Re: Indian Point Unit No. 2  
Docket No. 50-247  
NL-04-121

SUBJECT: **Reply to Request for Additional Information Regarding  
Indian Point 2 Stretch Power Uprate (TAC MC1865)**

**REPLY TO NRC REQUEST FOR ADDITIONAL INFORMATION REGARDING  
PROPOSED LICENSE AMENDMENT REQUEST FOR  
INDIAN POINT 2 STRETCH POWER UPRATE**

**Figure 1 - Peak Cladding Temperatures**

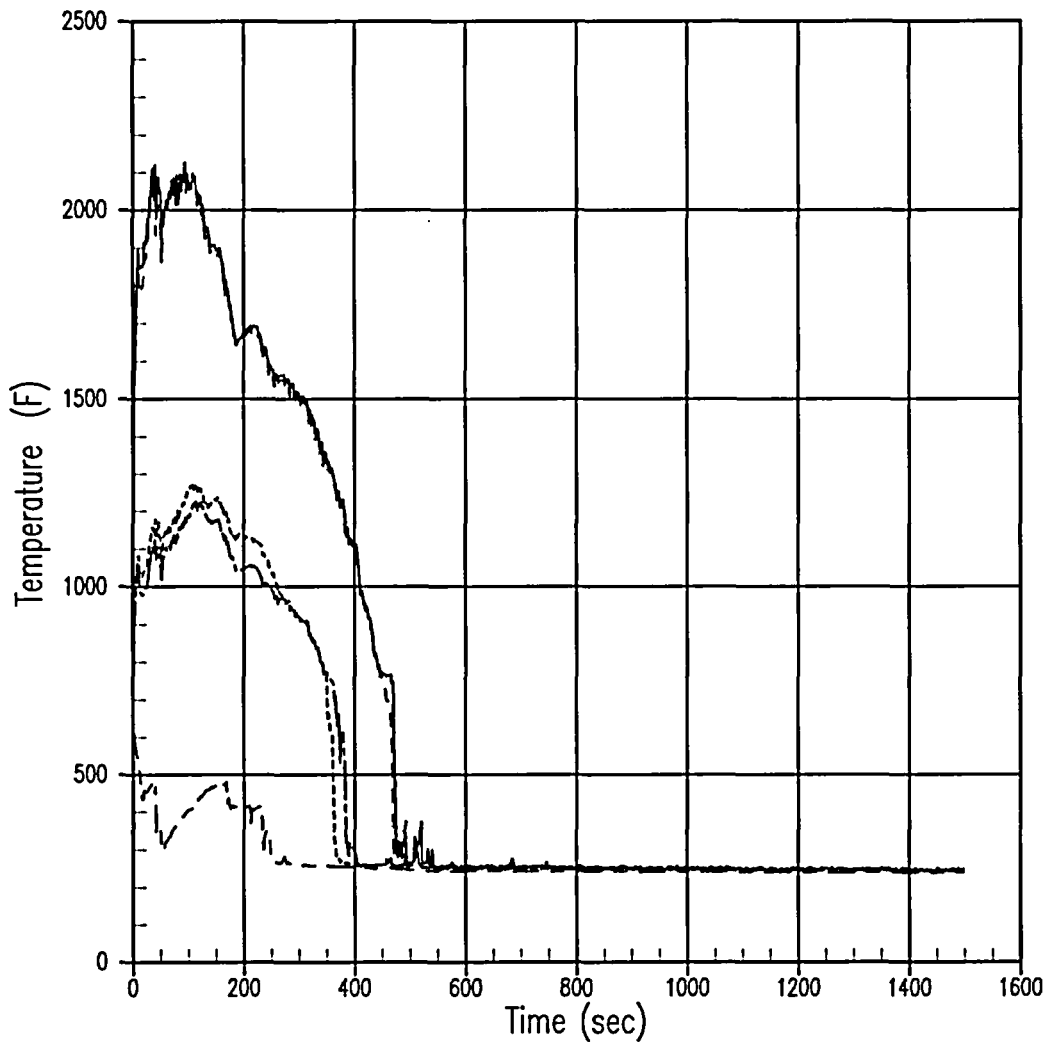
Attached is an update for the reply to LOCA Transient Question 4, previously provided in Entergy letter NL-04-100 dated August 12, 2004. This update reflects a correction to results reported for heat transfer in the downcomer region, which has a small effect on Figures 1 through 4, but the conclusion regarding the time to reach stable and sustained quench for LBLOCA is not changed by this correction.

Provide the LBLOCA analysis results (tables and graphs, as appropriate) to the time that stable and sustained quench is established.

In order to demonstrate stable and sustained quench, the WCOBRA/TRAC calculation for the maximum local oxidation analysis was extended. Figure 1 shows the peak cladding temperatures for the five rods modeled in WCOBRA/TRAC. This figure indicates that quench occurs at approximately 275 seconds for the low power rod (rod 5), 400 seconds for the core average rods (rods 3 and 4), and 500 seconds for the hot rod (rod 1) and hot assembly average rod (rod 2). Once quench is predicted to occur, the rod temperatures remain slightly above the fluid saturation temperature for the remainder of the simulation. Figure 2 shows the collapsed liquid level in the four downcomer channels and shows steady behavior, with the level in each quadrant remaining near the bottom of the cold leg. Figure 3 shows the collapsed liquid level in the four core channels and indicates a gradual increase in the core liquid inventory. This is consistent with the expected result based on the removal of the initial core stored energy and the gradual reduction in decay heat. Figure 4 shows the vessel liquid mass and indicates stable and increasing trend beginning at about 700 seconds. This indicates that the increase in inventory due to the pumped safety injection is more than offsetting the loss of inventory through the break. Based on these results, it is concluded that stable and sustained quench has been established for the Indian Point Unit 2 Large Break LOCA analysis.
